REFERRAL REPORT

TO: Vancouver City Council
FROM: General Manager of Planning, Urban Design and Sustainability
SUBJECT: CD-1 Text Amendment: 650 West 41st Avenue (Oakridge Centre)

“Figure 1 – Sub-Areas

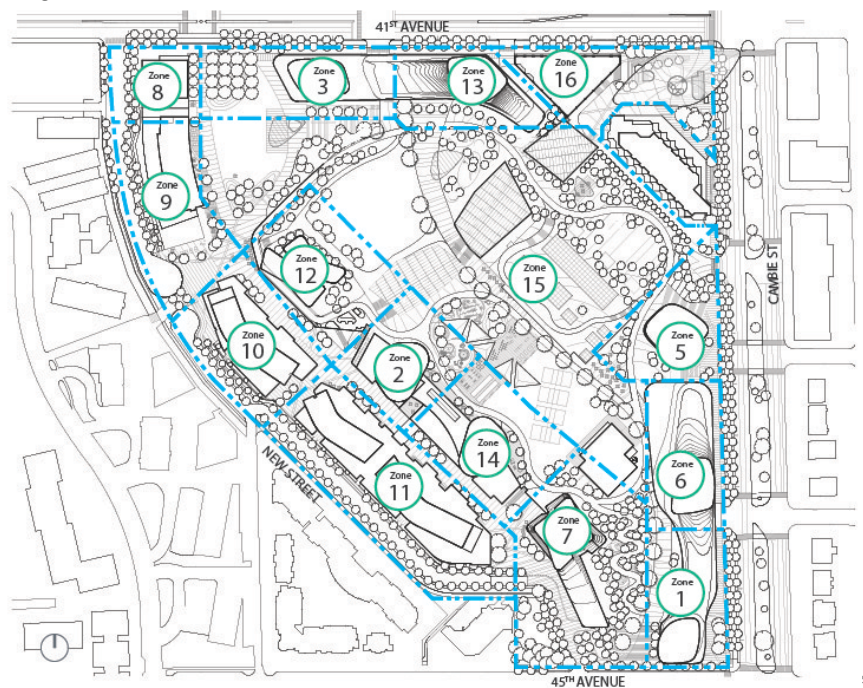
The PDP included refinements that changed the form and public realm of the project, including the elimination of one tower and changes to the locations of some towers. In order for the current by-law to reflect these modifications, the “Figure 1 - Sub-Areas” diagram in Section 3 needs to be revised (see proposed diagram in Appendix A). The sub-areas are used to regulate building height, so the table in Section 7.2 also requires modification to remove sub-area 4, which was the sub-area for the tower now eliminated.

1. This By-law amends the indicated provisions of By-law 3568.
2. In section 3, Council strikes out “16 sub-areas” and substitutes “15 sub-areas”.
3. In section 3, Council strikes out Figure 1 – Sub-Areas and substitutes the following:

Sub-Area	Maximum building heights (in meters)
1	143.9 m
2	166.3 m
3	191.9 m
5	213.2 m
6	186.3 m
7	191.9 m
8	149.0 m
9	116.0 m
10	127.2 m
11	115.4 m
12	194.9 m
13	221.5 m
14	184.2 m
15	112.9 m
16	118.2 m
